**08-AFC-1**

Ref: Final Comments to Avenal Energy (08-AFC-1) Preliminary Staff Assessment

**GENERAL AND SPECIFIC COMMENTS TO THE PSA**

**Revised Exhibit 83-3**

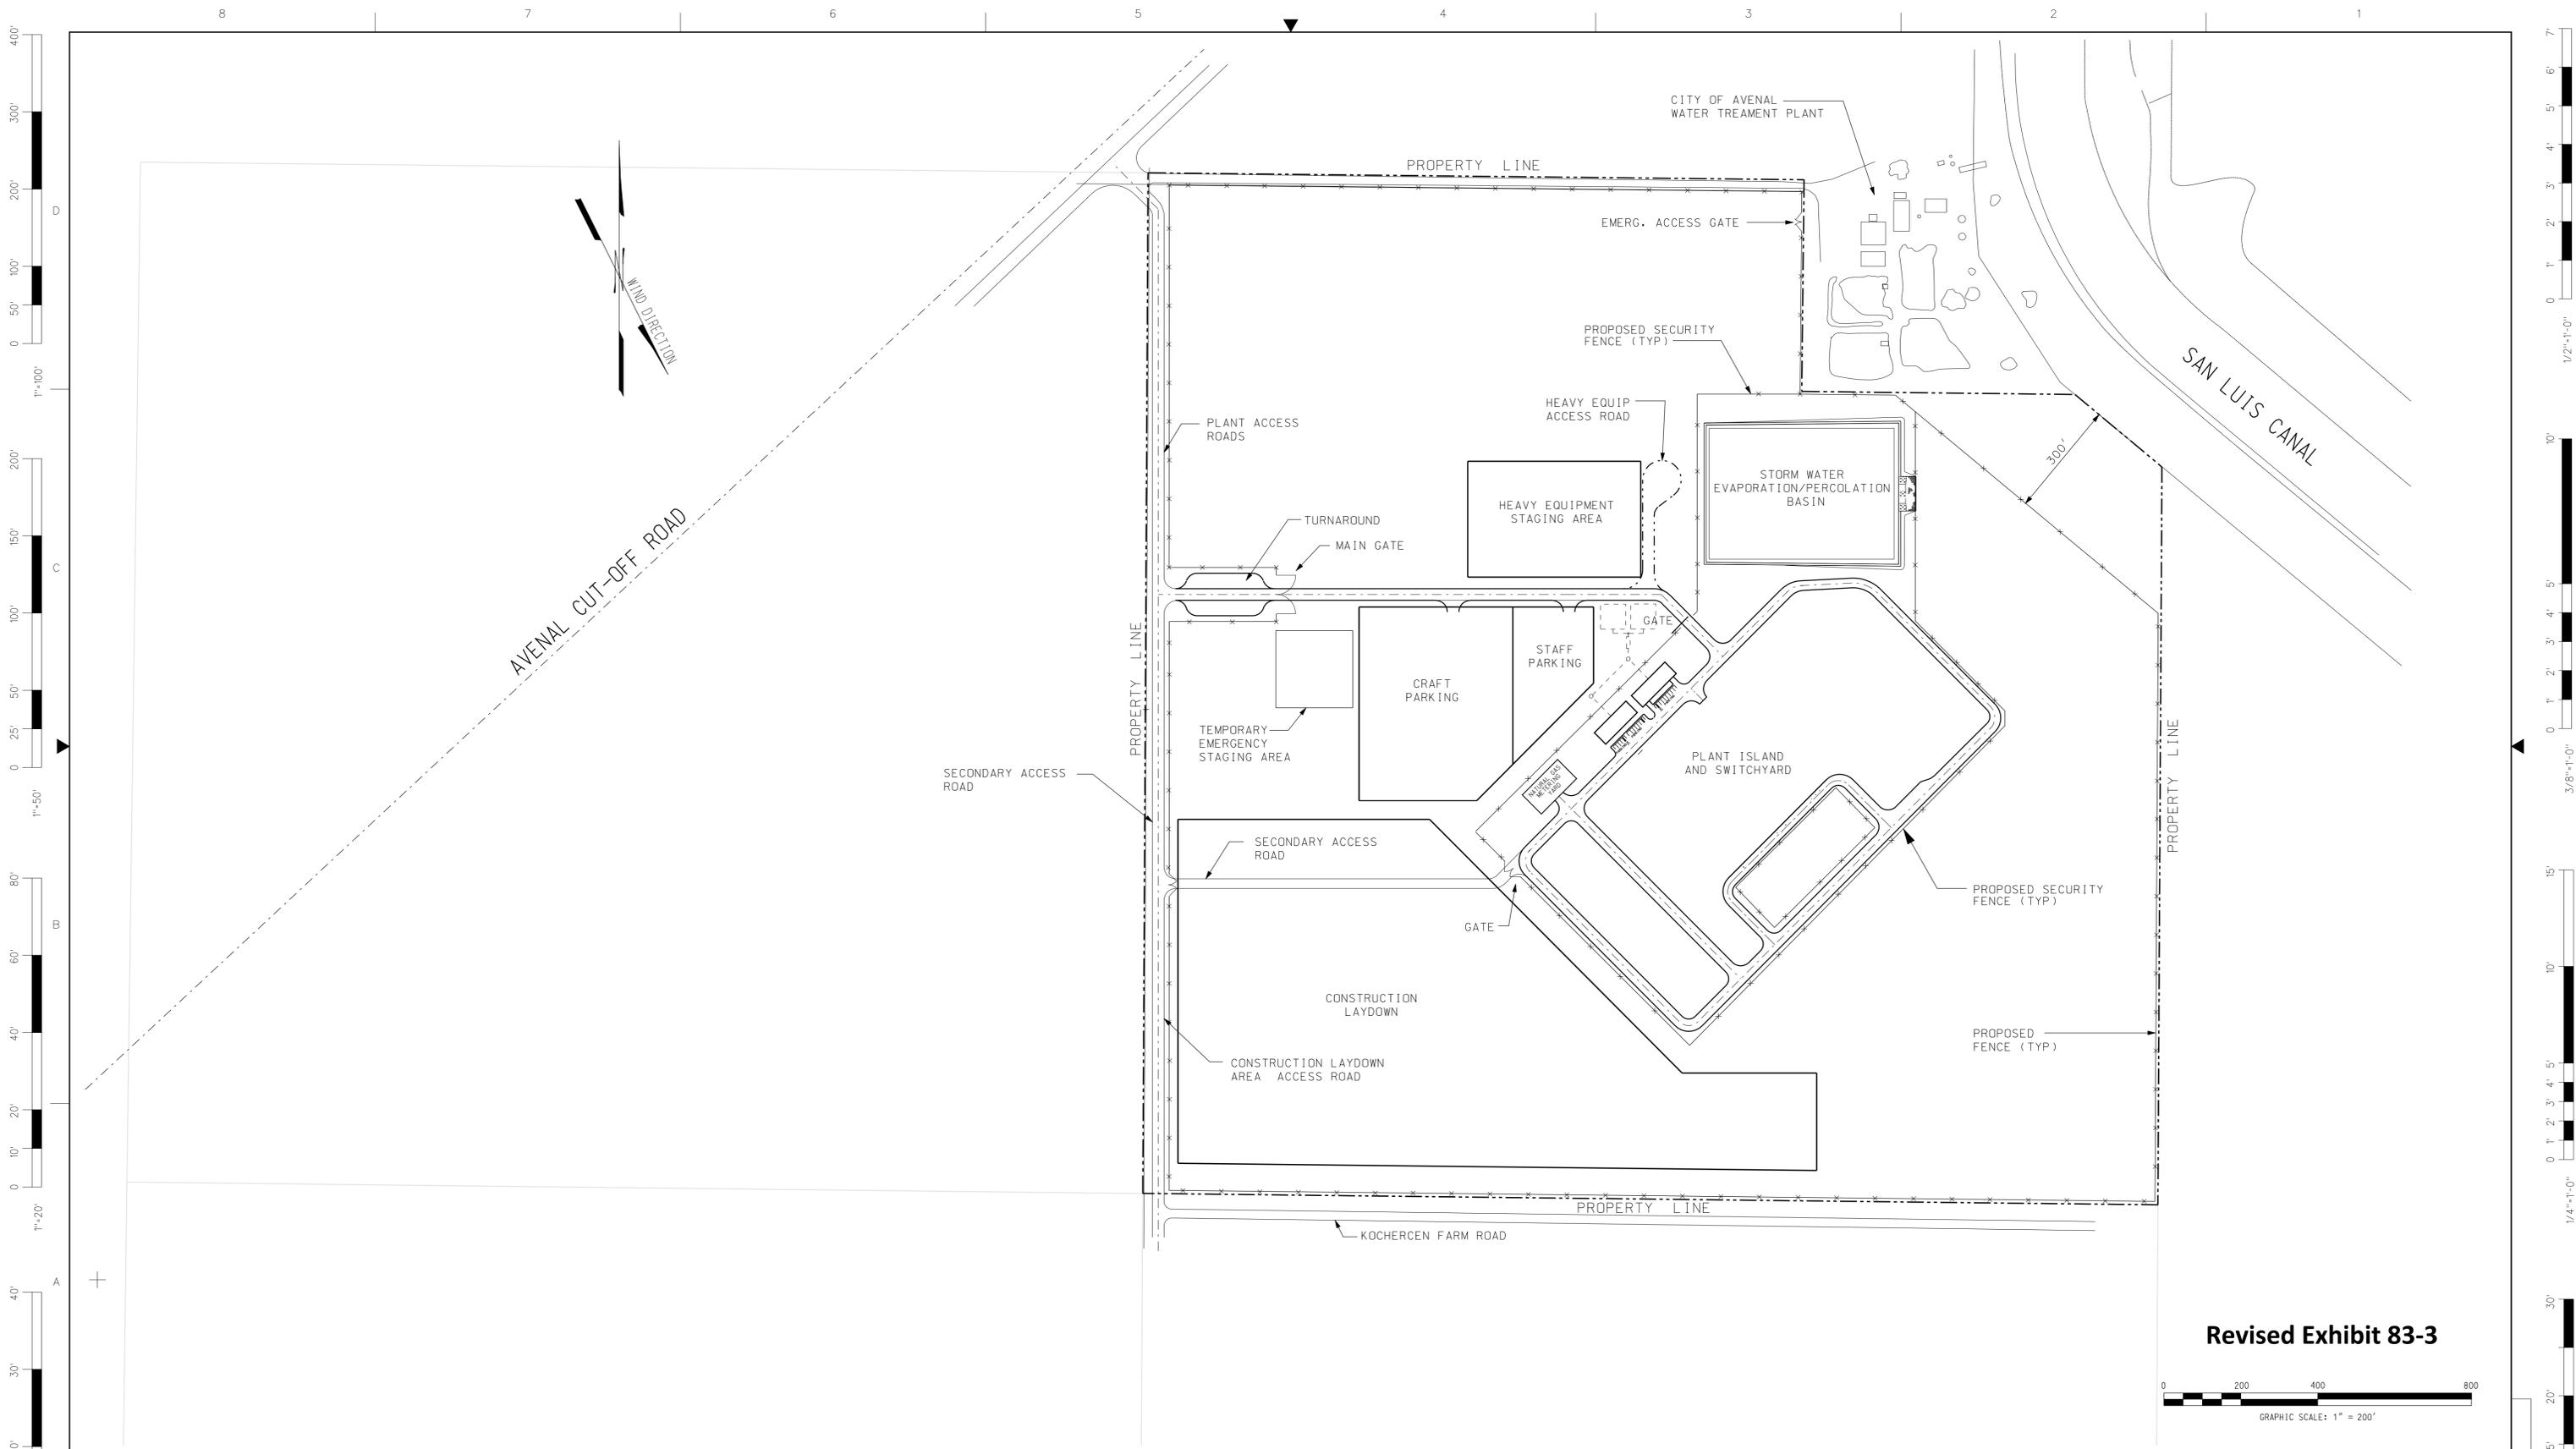
- **Attachment 2 – Revised Exhibit 83-3:** This exhibit provides a site drawing with the modified storm water basin location and 300-foot setback that was agreed upon during the February 18, 2009 workshop.

Although the applicant does not agree with the scientific basis for a 300-foot setback from the United States Bureau of Reclamation right-of-way, the applicant has agreed to provide the 300-foot setback requested by CEC Staff and United States Fish and Wildlife Service as a settlement of this issue. In addition, ~~Currently the applicant, United States Fish and Wildlife Service, California Department of Fish and Game, and Energy Commission staff disagree on the setback that the project facilities should have from the adjacent United States Bureau of Reclamation right-of-way and the California Aqueduct San Luis Canal. The setback is important to preserve a larger area for foraging and movement for San Joaquin kit fox and other species such as the Tulare grasshopper~~
